CITY OF WACONIA
July 6, 2023

Meeting Date:	August 3, 2023
Item Name:	PUBLIC HEARING - Comprehensive Plan Amendment - 7845 County Road 10 North, Waconia Township
Originating Department:	Community Development
Presented by:	Lane Braaten
Previous Commission Action (if any):

Item Name: PUBLIC HEARING - Site Plan, Design Review & Variance - 219 Frontage Road East

The applicant, Kelsey Jarrett/HTG Architects, has submitted applications for Site Plan, Design Review and a Variance for the property located at 219 Frontage Road East. The applicant is proposing an addition to the Crusher Crossfit building. The applications include the following:

EXTERIOR ELEVATIONS

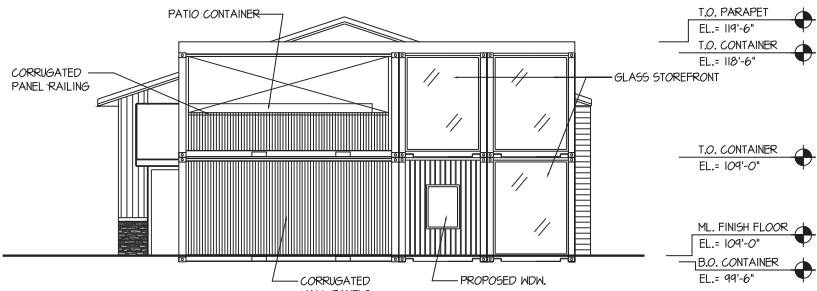
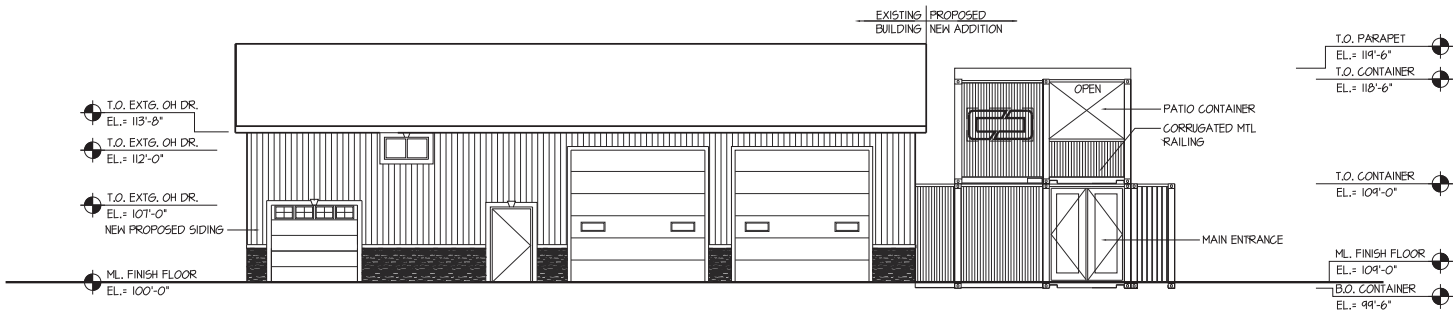
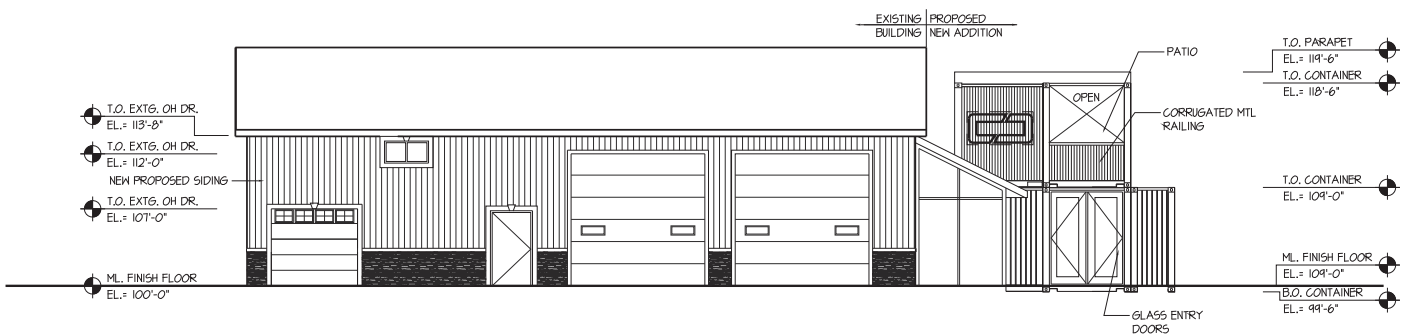
The Planning Commission should discuss the proposed metal shipping container addition to the existing building.

The proposed shipping container addition would be a significant departure from the existing building design on the subject property and in the area. The Planning Commission should discuss if additional façade improvements should be required (i.e. painting, materials, etc.) on the Crusher Crossfit building or the principal structure on the property to meet this design standard.
